TECHNICAL REVIEW OF 2021 and 2022 ENVIRONMENTAL MONITORING REPORTS FOR SAVANNAH RIVER SITE F-AREA AND H-AREA TANK FARM FACILITIES

Date: September 2023

Primary Documents Reviewed:

Figure 9 2022 Nonvolatile Beta Results (pCi/L) for the FTF (1 pCi/L = 0.037 Bq/L). Image Credit: Figure 10 SRNS-RP-2022-01106.

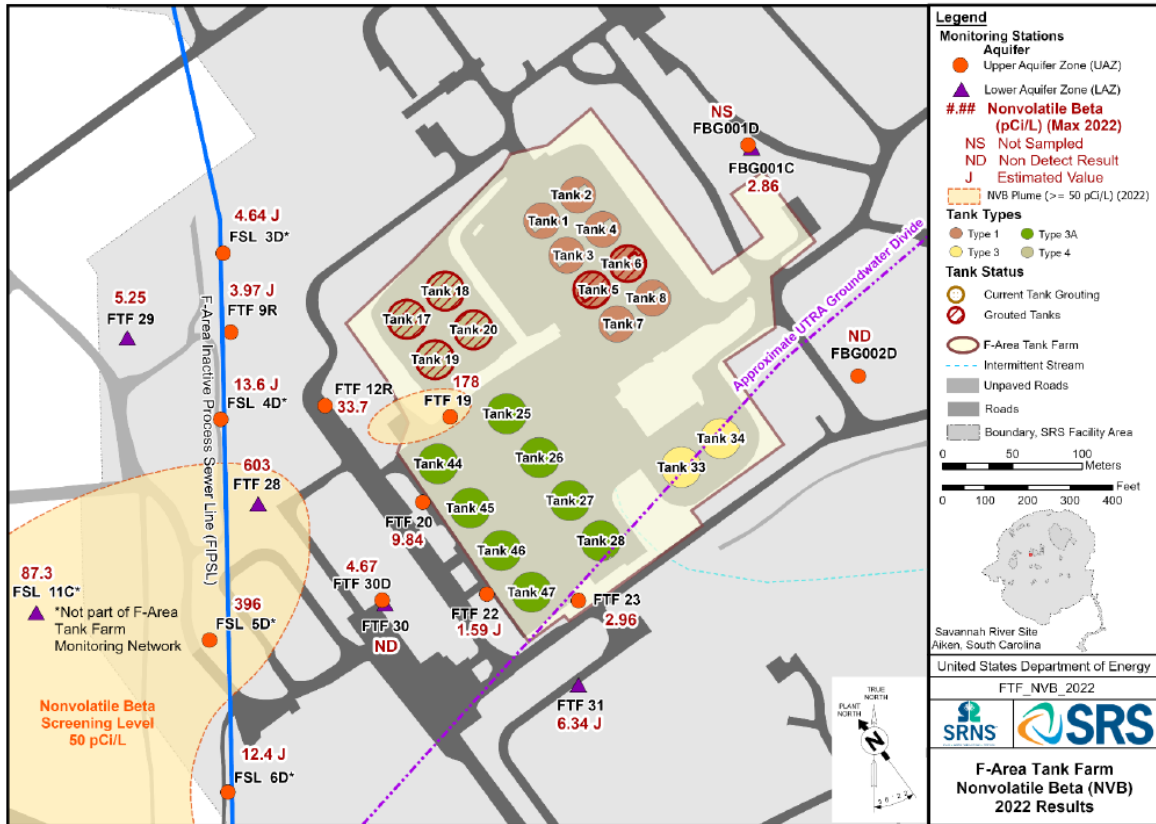
- In 2022, FTF-28 and FTF-19 exceeded the screening level for non-volatile beta. Because well FTF-12R has historically been above the screening level, FTF-12R samples were also analyzed for Tc-99 in the first quarter of 2022, although nonvolatile beta concentrations were below the screening level. See Figure 9 for a figure depicting the non-volatile beta plume at FTF.

- A nonvolatile beta plume continues to be associated with the FIPSL and wells FTF-28 near the FTF and FSL-11C further downgradient of FTF.
- The basis for the association of the FIPSL with the nonvolatile beta plume at FTF-28 is the relatively low pH of 5.05 at this well versus the average pH of 5.61 for LAZ wells at FTF.

Figure 10 Hydrogen Ion Concentration Versus Non-Volatile Beta Concentration

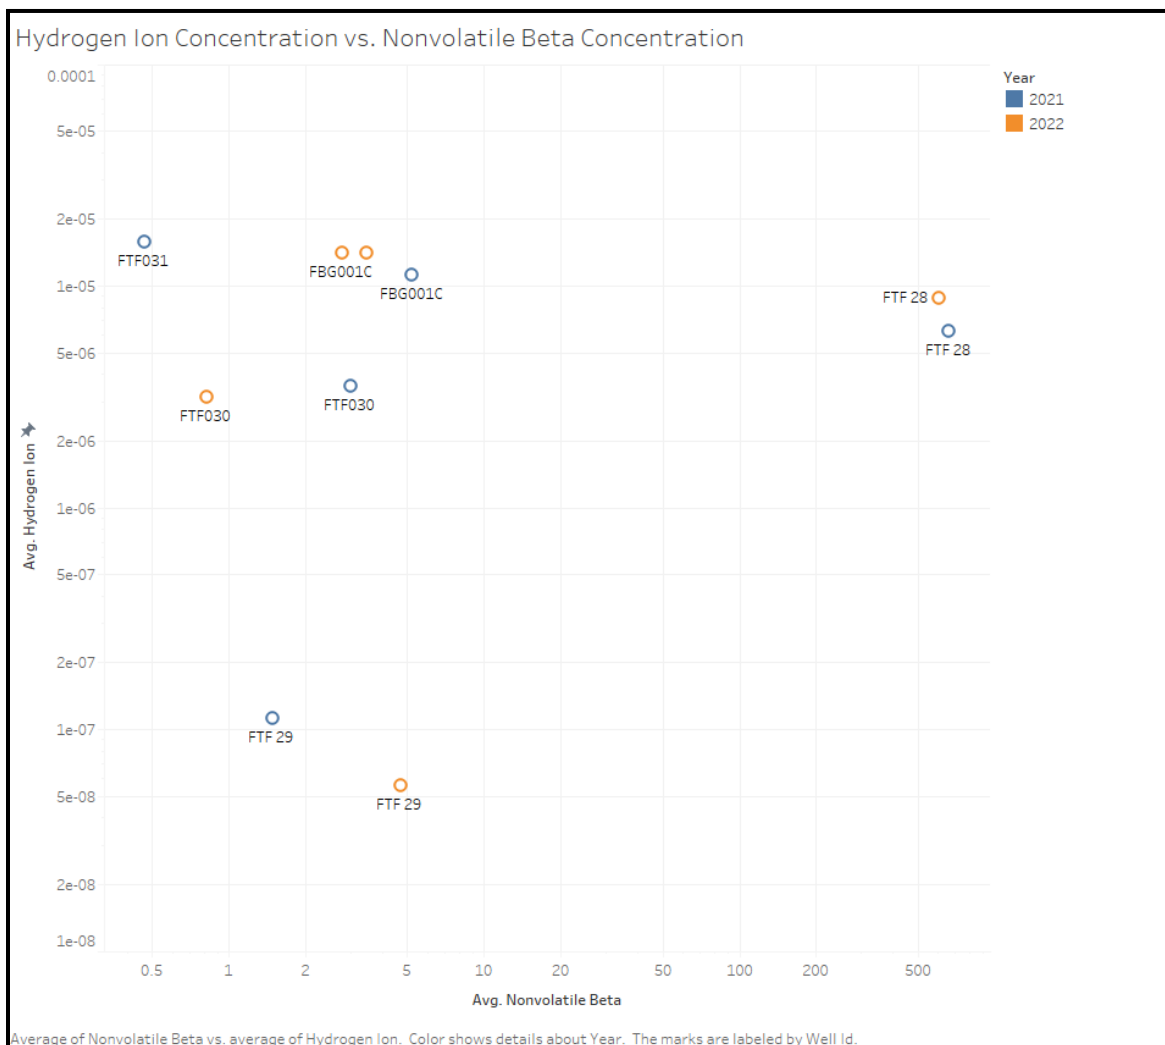
NRC would note that the pH in LAZ wells at FTF appears lower in recent years. Because DOE relies on the relatively low pH at FTF-28, compared to other LAZ wells, as the basis for assuming the source of the nonvolatile beta/Tc-99 plume was from acidic releases from the FIPSL, further evaluation of the cause for the variability in pH at other LAZ wells such as background well FGB-1C and FTF-31 would be informative. Figure 10 below shows the

hydrogen ion concentration at FTF-28 falls between wells FTF-31 and FGB-1C (which have relatively high hydrogen ion concentration and lower pH) and FTF-29 and FTF-30 (which have relatively low hydrogen ion concentration or higher pH). In particular, the pH at well FTF-29 appears anomalously high (or hydrogen ion concentration anomalously low). As evidenced in Figure 10, there does appear to be a strong correlation between pH and non-volatile beta (or Tc-99) concentration. A more extensive evaluation of historical trends in pH is provided in ML19280A059 and is not repeated here.
